UNITED STATES PATENT AND TRADEMARK OFFICE

Office Action Summary

09/376,875

DETAILED ACTION

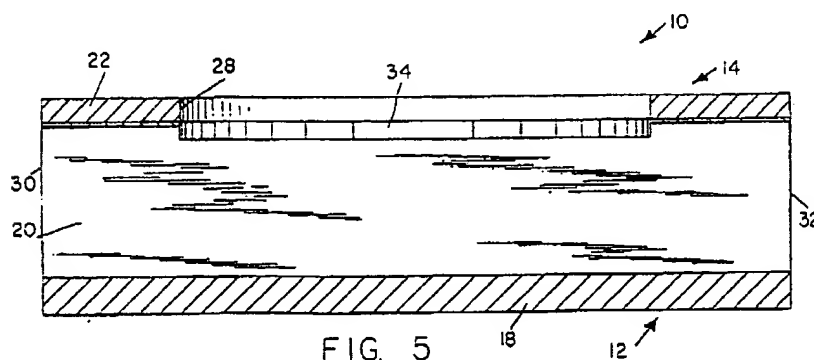
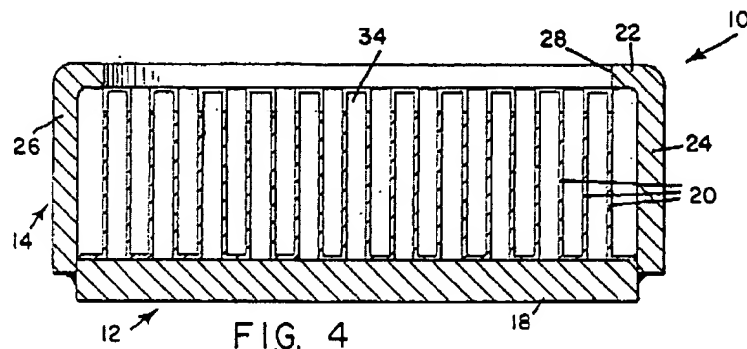
The Examiner agrees with applicants' characterization of Morosas. However, the claims do not recite "semi-circular" arches and do not preclude a housing mounted on top of the fins. The definition of arch is "A structure, especially one of masonry, forming the curved, pointed, or *flat upper edge of an open space* and supporting the weight above it, as in a bridge or doorway." Lastly, as shown below, Morosas (column 3, lines 15-20 and 63-65) discloses severed or trimmed openings forming a plenum 34 in accordion folded fins 20.
